ADDENDUM REPORTS

Application Number:	AWDM/1481/21	Recommendation - Approve subject to a s.106 Agreement, the receipt of amended plans and outstanding consultee responses.
Site:	Land At Former 5 Brighton Road, Shoreham-By-Sea	
Proposal:	Proposed mixed-use re-development between 3 and 8 storeys comprising 21 townhouses, mixed-use apartment block of 24 flats, riverside walk, landscaping, and parking.	
Applicant:	Cayuga 011 LLP	Ward: Southwick Green
Agent:	Lewis and Co Planning SE Ltd	
Case Officer:	Stephen Cantwell

Application Number:	AWDM/0585/22	Revised Recommendation - Delegate to approve subject to the completion of a s106 agreement.
Site:	Land At 68 And South Of 68 To 86 Manor Hall Road, Southwick	
Proposal:	Erection of 22 residential units, with associated landscaping and access arrangements	
Applicant:	West Sussex Property Development LLP	
Agent:	Nexus Planning	
Case Officer:	James Appleton

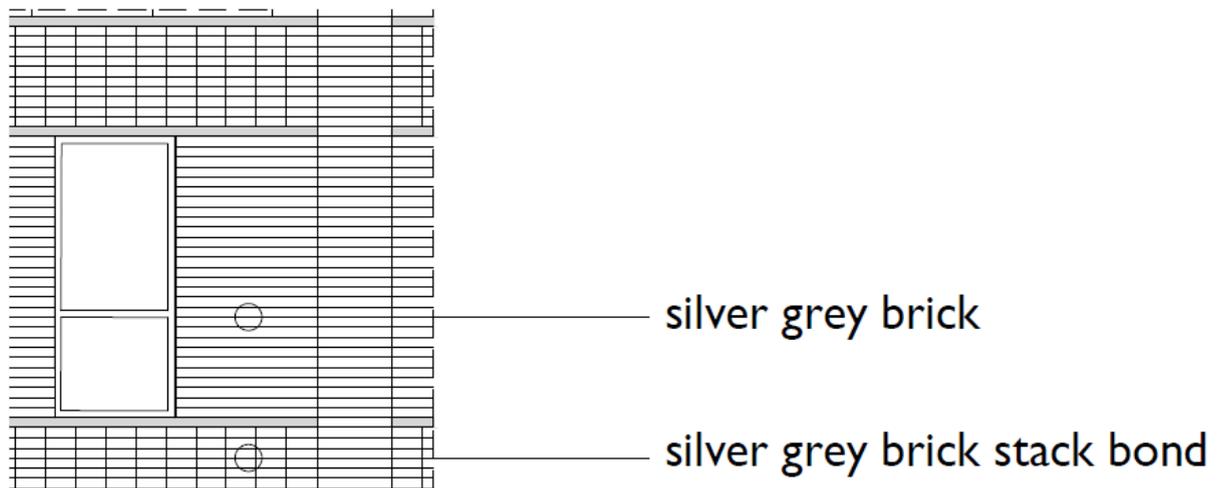
Proposed brick colour: The photo below shows a close-up of the proposed brick, it is clearly a silver-grey not a grey-grey concrete colour. It has a variegated surface and is very light responsive

the proposed image of the courtyard (below) contains a close-up of the brick, this is taken from an actual photo of the proposed brickwork.

Generally, the brickwork is a stretcher bond unless otherwise stated. The stack bond is only used on the four storey houses and in defined panels framed by the vertical piers and the secondary red/brown secondary brick string courses. The concept is to provide a variety of visual texture to the elevations & to give the 4-storey houses a subtly different look to the other two blocks.

The secondary red brown brick makes a reference to the bricks of the adjoining Kingston Wharf development. It is used for string courses through the development and as the main brick to the links between the housing terraces and flats block to provide a visual separation. It is also used on the back walls to the recessed balconies in the flats block to provide visual contrast & depth to the elevations

The clarification of brickwork bond shows considered and selective use of stack bound on areas of the four storey terraces only. Whether the grey shade and texture as indicated is suitable. Officers have reservations and consider that a shade which is closer to that of the lighthouse would be appropriate here, but acknowledge that this is a matter of judgement. Samples of materials would be required, which could be achieved under the proposed condition no.6.

Revised Plans

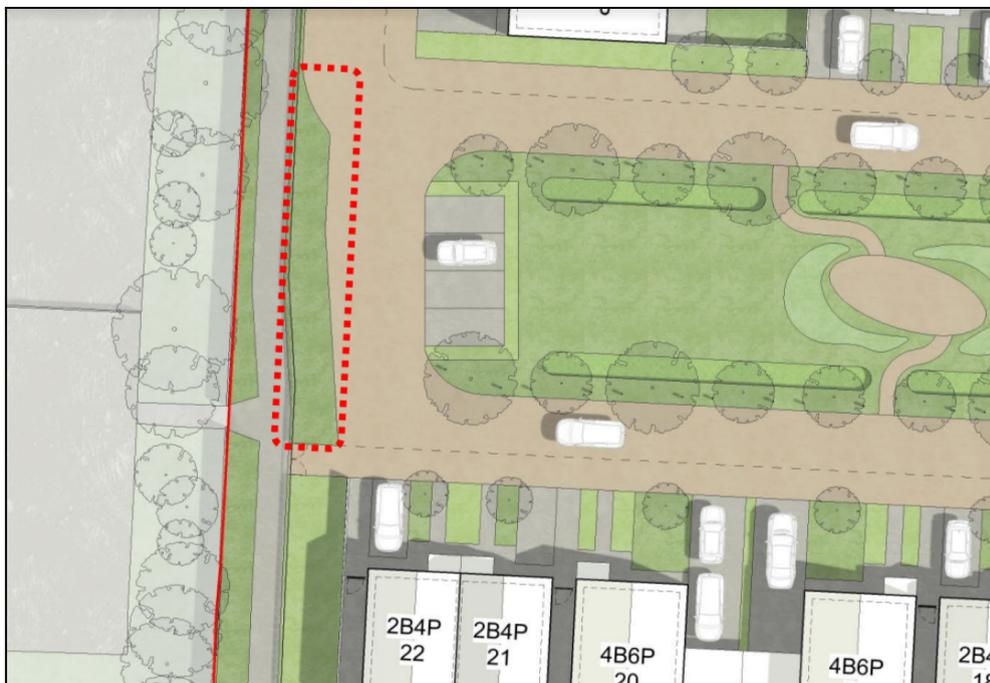
As indicated in the Committee report the applicant has now agreed to replace 3 visitor parking spaces with a landscaped strip adjacent to the cyclepath leading to Southwick Recreation Ground (extract below).

'We note your report suggests that the new landscape area could accommodate trees. The submitted plans show native hedge and groundcover planting only. Unfortunately, trees cannot be accommodated in this location as the whole of this strip of soft landscape falls within the 3m easement of an existing Southern Water sewer which means we are restricted by their guidance on what can be planted in this zone; they only allow ground cover and hedge planting.

WSCC Highways confirms that it has no objection to the amended plan which reduces the number of parking spaces by 3 to increase the level of replacement landscaping to be delivered.

The amended plan is acceptable and it is noted that the Southern Water easement would not allow replacement tree planting, however, the revised plan would allow for shrub and hedge planting which will ensure that the landscaped character to the cyclepath is maintained following the implementation of the development. As indicated by the agent the financial contribution would reduce to **£27,838**.
